APICAL INDUSTRIES, INC.
dba DART AEROSPACE

ENGINEERING CHANGE NOTICE NO.

05110

DWG TITLE: STRUT ASSY

STRUT ASSY

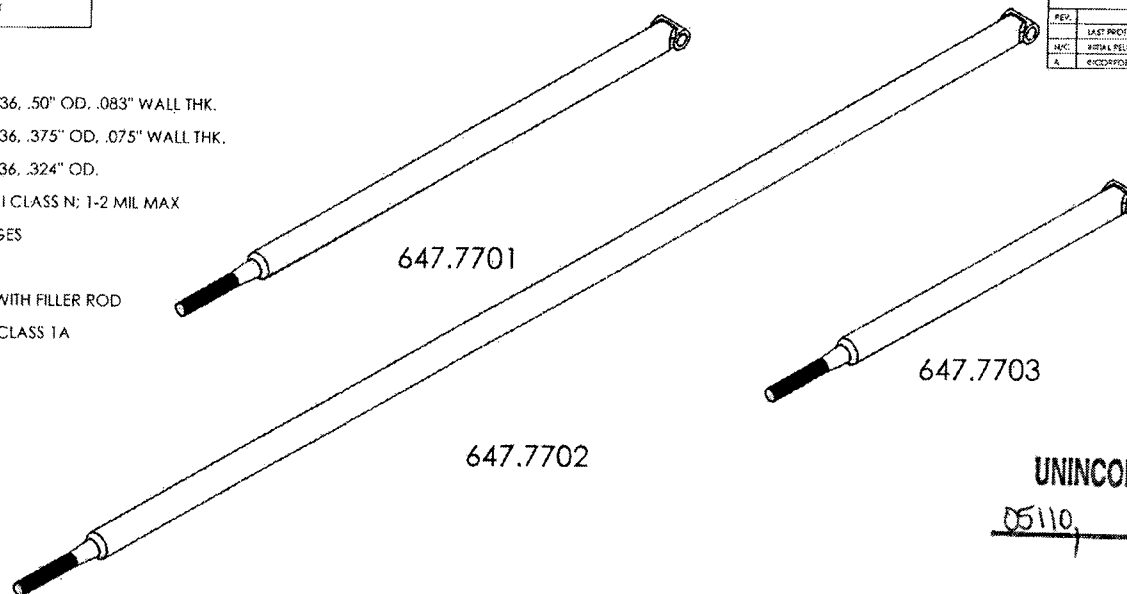
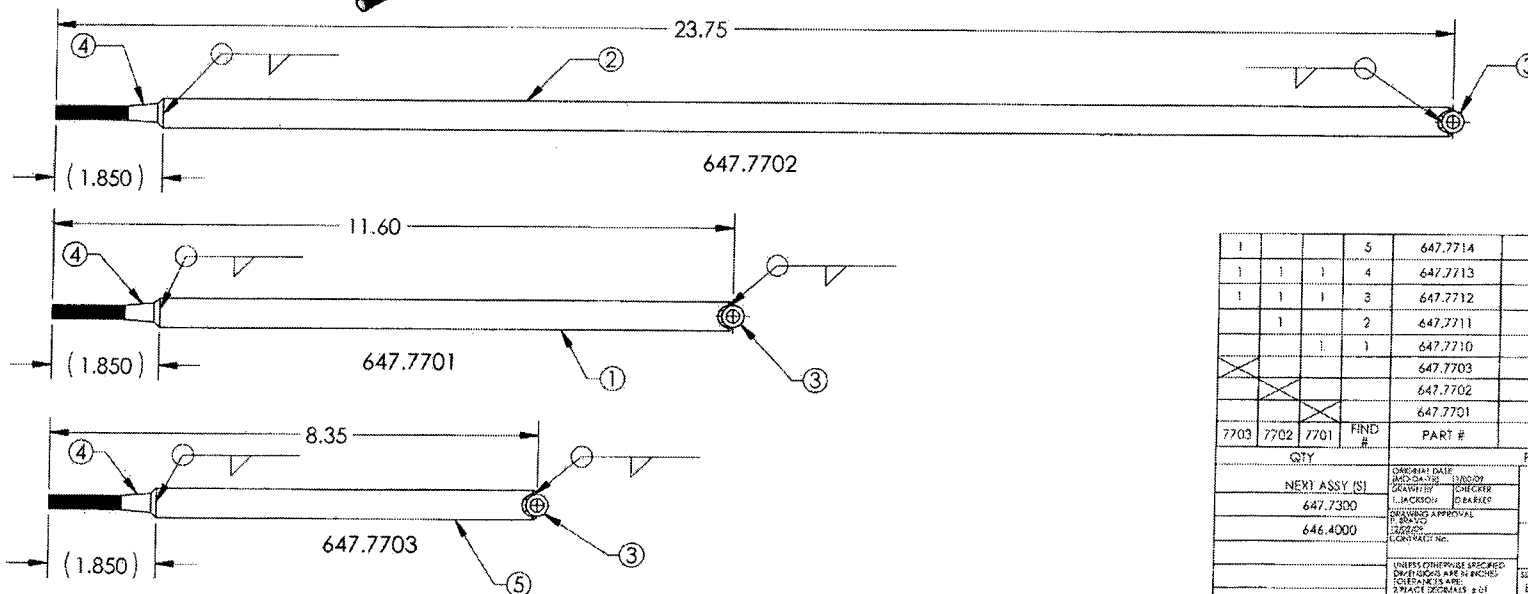
REASON: REVISED FINISH CALLOUT AS PER ECR 15-209

SHEET 1, NOTES IS:

- 1 MATERIAL: 4130 STEEL PER AMS-T-6736, .50" OD, .083" WALL THK.
- 2 MATERIAL: 4130 STEEL PER AMS-T-6736, .375" OD, .075" WALL THK.
- 3 MATERIAL: 4130 STEEL PER AMS-T-6736, .324" OD.
- 4 FINISH: PRIME IAW MIL-P-2337J TYPE I CLASS N; 1-2 MIL MAX
5. DEBURR AND BREAK ALL SHARP EDGES
6. IDENTIFY IAW MPP-120.
- 7 WELD IAW MIL-STD-2219, TIG WELD WITH FILLER ROD
- 8 FINISH: CAD PLATE IAW QQ-P-416F CLASS I TYPE II
- 9 MASK THREAD PRIOR TO FINISH

- 1 MATERIAL: 4130 STEEL PER AMS-T-6736, .50" OD, .083" WALL THK.
- 2 MATERIAL: 4130 STEEL PER AMS-T-6736, .375" OD, .075" WALL THK.
- 3 MATERIAL: 4130 STEEL PER AMS-T-6736, .324" OD.
- 4 FINISH: PRIME IAW MIL-P-2337J TYPE I CLASS N; 1-2 MIL MAX
- 5 DEBURR AND BREAK ALL SHARP EDGES
- 6 IDENTIFY IAW MPP-120.
- 7 WELD IAW MIL-STD-2219, TIG WELD WITH FILLER ROD
- 8 FINISH: CAD PLATE IAW MIL-C-5541 CLASS 1A
- 9 MASK THREAD PRIOR TO FINISH
